PRODUCT / PROCESS CHANGE NOTIFICATION

| 1.2 PCN No. | IPG/14/9008 | |
| 1.3 Title of PCN | Linear Voltage Regulator and Reference BU: New Enhanced TO220 Single Gauge Frame | |

PACKAGE ROBUSTNESS

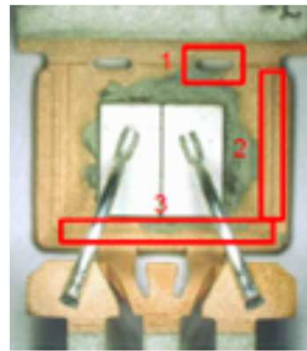
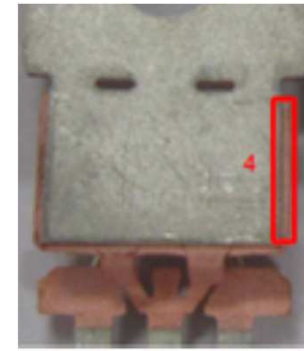
With the aim to improve the Package Robustness, **in particular the crimping resin/frame**, we changed some mechanical parameter related to the frame. In particular we worked on the Holes, Grooves and Downset characteristics implementing:

- ❖ **Larger Ovoid Holes (1)**
- ❖ **Deeper Grooves (2)**
- ❖ **Deeper Downset (3)**

First and Last Version

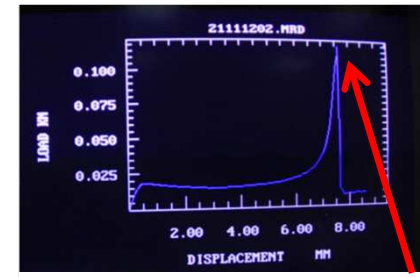
In order to verify the effectiveness of the above changes we performed, in collaboration with the CCR (Research Center at the Catania University), the **Body Crack Test**. According to the test results we found out a significant improvement vs the first version **(60N vs. 28N)**

Max Load=60N
